**City of Portland, Maine - Building or Use Permit Application** 389 Congress Street, 04101, Tel: (207) 874-8703, FAX: 874-8716

BUILDING PERMIT REPORT

REASON FOR PERMIT: Above ground pool and deck

398-A-8  
53 Summit St

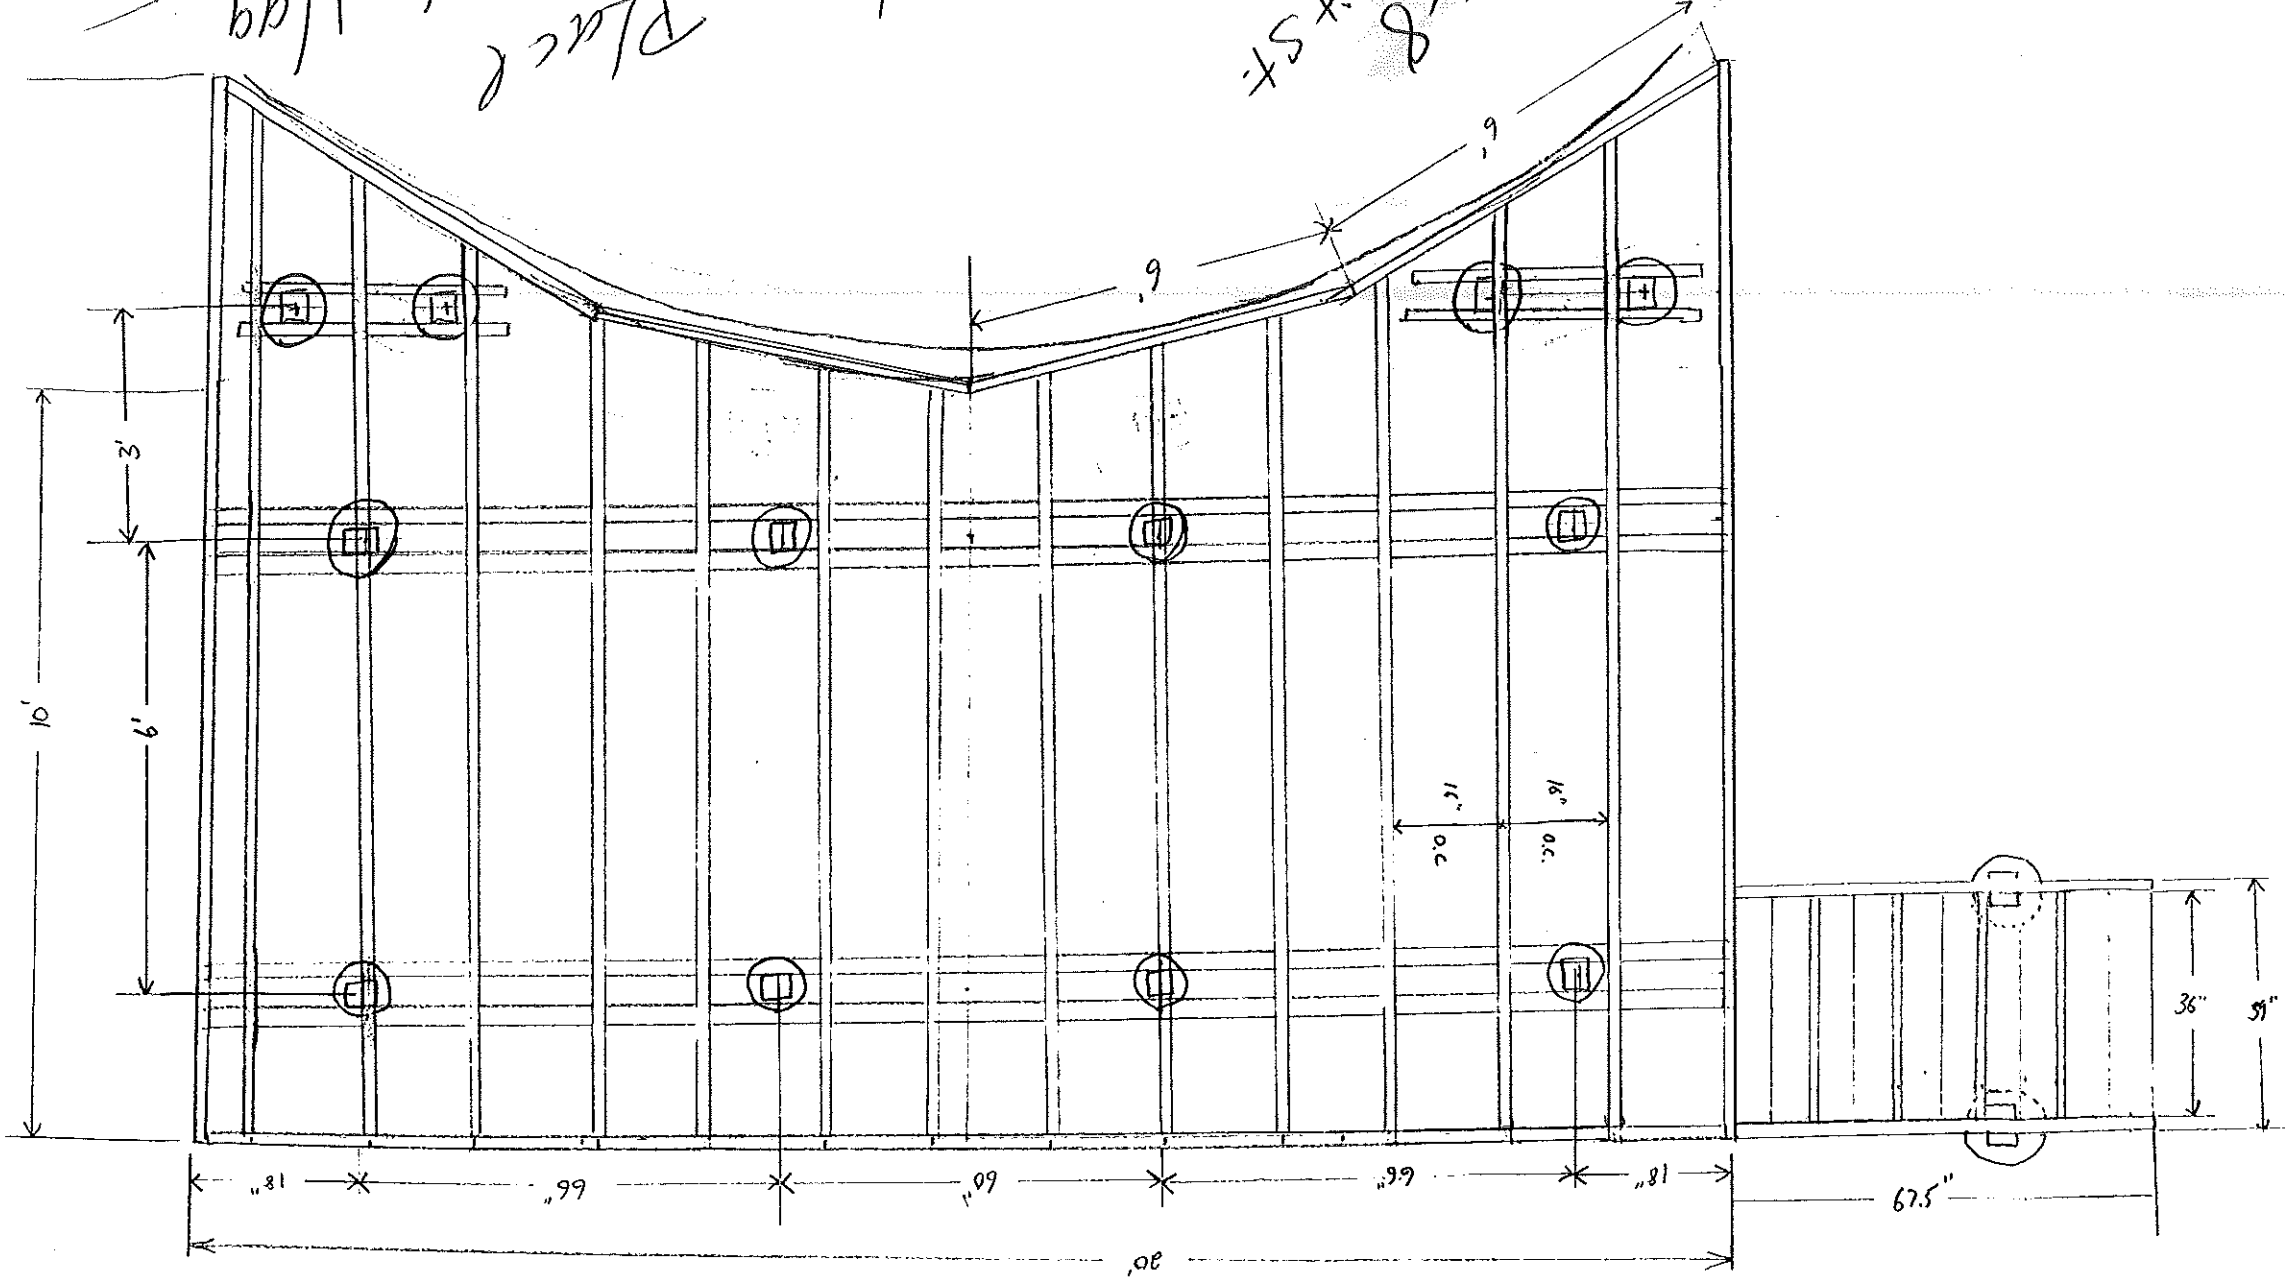
Pool  
Please Place  
with Porcelain  
22/11/1/99  
OK

OK 10
